Sign Variance Report 1997 Bloor Street West

Date:	December 21, 2006
To:	Etobicoke York Community Council
From:	Director, Community Planning, Etobicoke York District
Wards:	Ward 13 – Parkdale High Park
Reference Number:	File No. 06 188040 ZSV

Attachment 1: Front Elevation & Sign Details

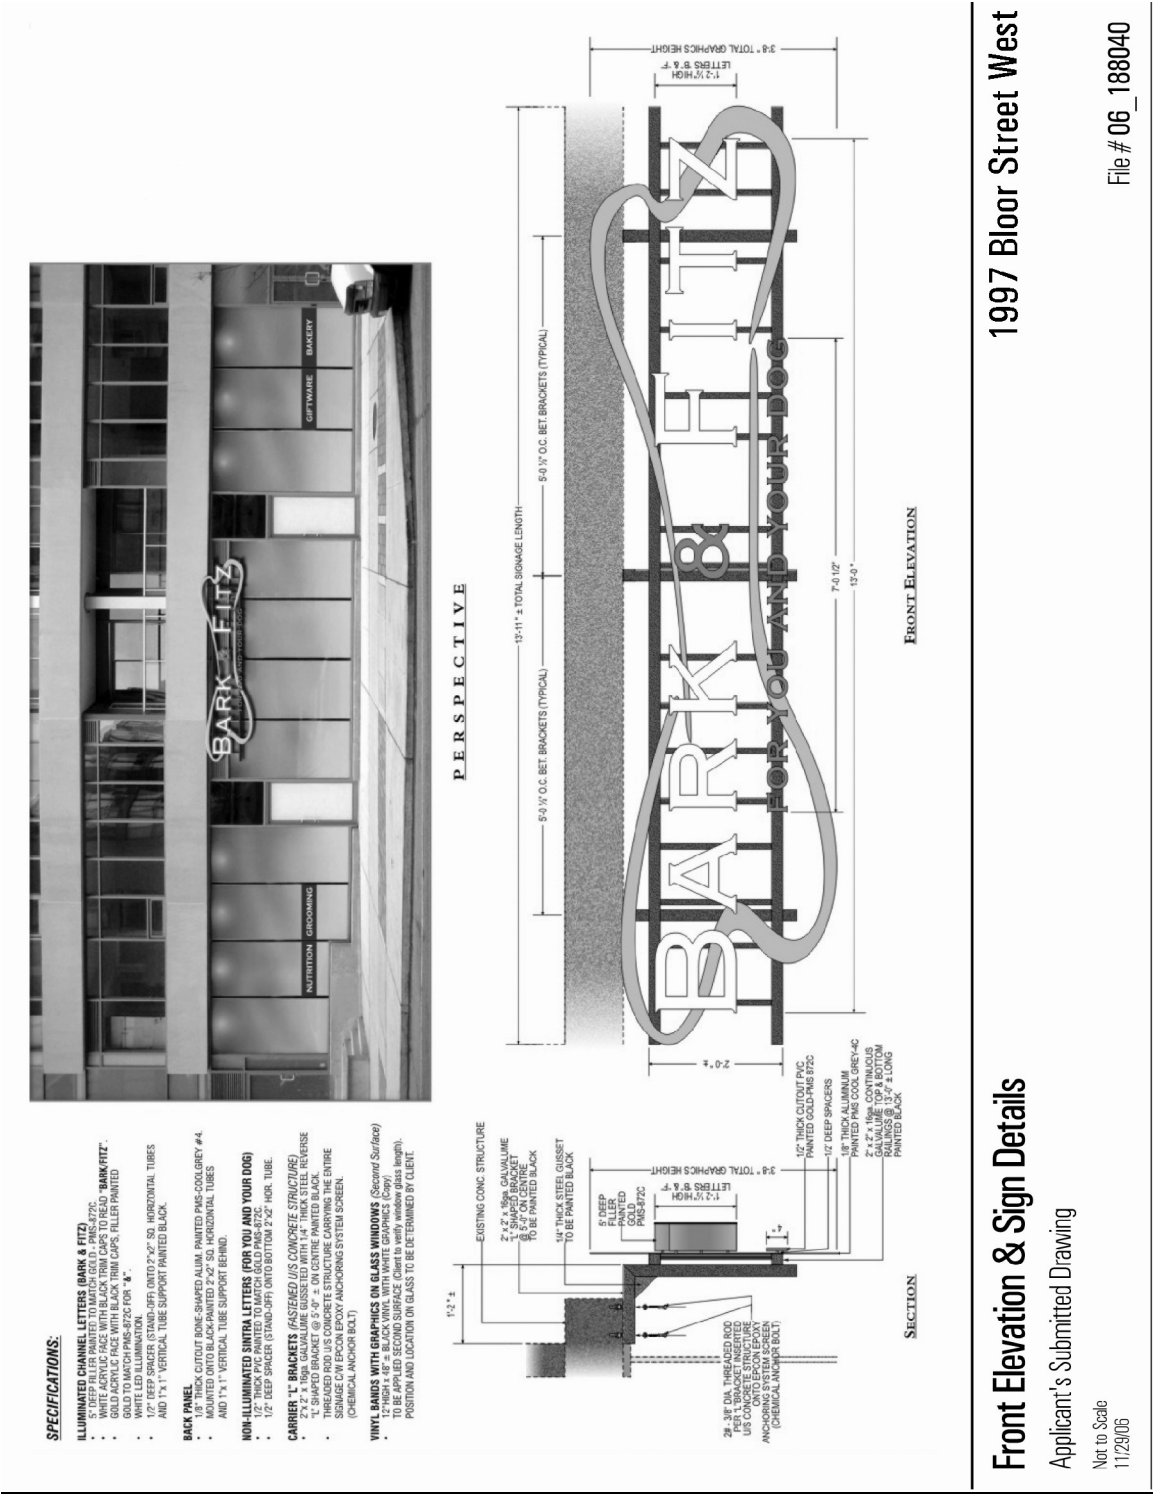
The property is located at the southeast corner of Bloor Street West and Ellis Park Road in a “MCR” zone. The property contains a six-storey building with retail uses at the grade level. The north wall of the business unit occupied by “BARK & FITZ” is constructed with tempered glass. The applicant is requesting permission to erect an illuminated fascia sign (“BARK & FITZ”) in the form of individual letters on the north elevation of the unit. The sign is 4.24 metres wide and 1.12 metres high with an area of 4.75 square metres.

North Elevation

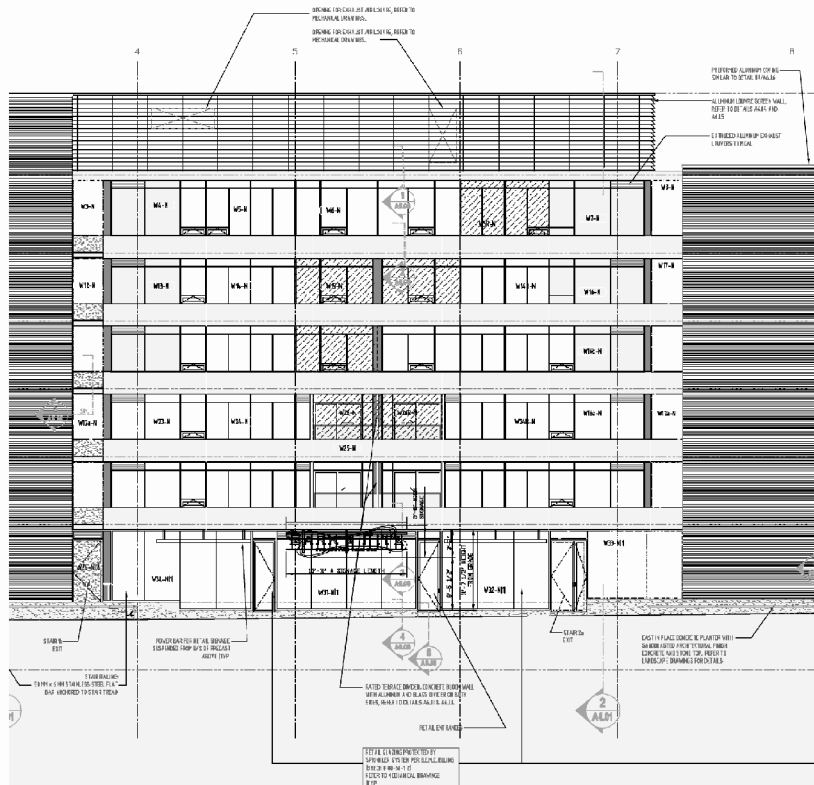
Sign By-law Section and Requirements	Applicant's Proposal	Required Variance
Chapter 297-10E (6)	The sign would obstruct or interfere with windows of the building.	A sign obstructing or interfering with a window of a building is not permitted.

The variance is required because the sign may obstruct or interfere with the top portion of the window. The front wall of the business unit is constructed of tempered glass panels and it is staff's opinion that some obstruction or interference to the upper portion of the glass wall would not adversely impact the outward views or inward light transmission into the building.

1. City Council approve the requested variance to permit for identification purposes, an illuminated fascia sign for identification purposes on the north elevation of the building at 1997 Bloor Street West; and
2. City Council direct staff to advise the applicant, upon approval of a variance, of the requirement to obtain the necessary sign permits
